Intel[®] Pentium[®] 4 Processor Specification Update

Release Date: November 2001

Order Number: 249199-015

The Intel[®] Pentium[®] 4 processor may contain design defects or errors known as errata which may cause the product to deviate from published specifications. Current characterized errata are documented in this Specification Update.

The following figure will be added as Figure (new). THERMTRIP# Power Down Sequence

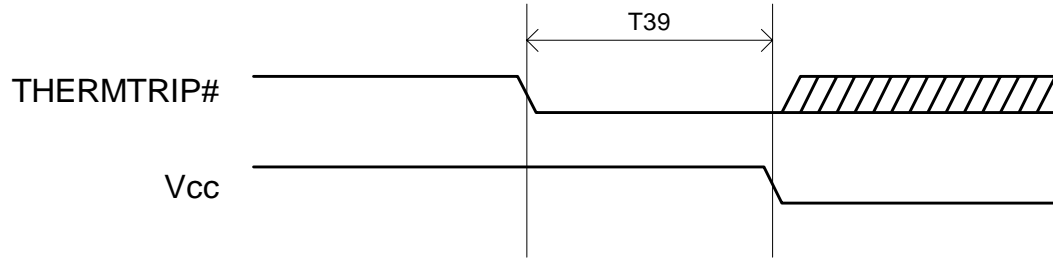
N3. THERMTRIP# Clarification

Several parts of the *Intel® Pentium® 4 Processor in the 423-pin Package* datasheet will be updated as follows to clarify the functionality of the Thermtrip# pin.

The following specification will be added to Table 13, page 24.

<u>T# Parameter</u>	<u>Min</u>	<u>Max</u>	<u>Unit</u>	<u>Figure</u>	<u>Notes</u>
T39: THERMTRIP# to removal of power	N/A	500	ms	(new)
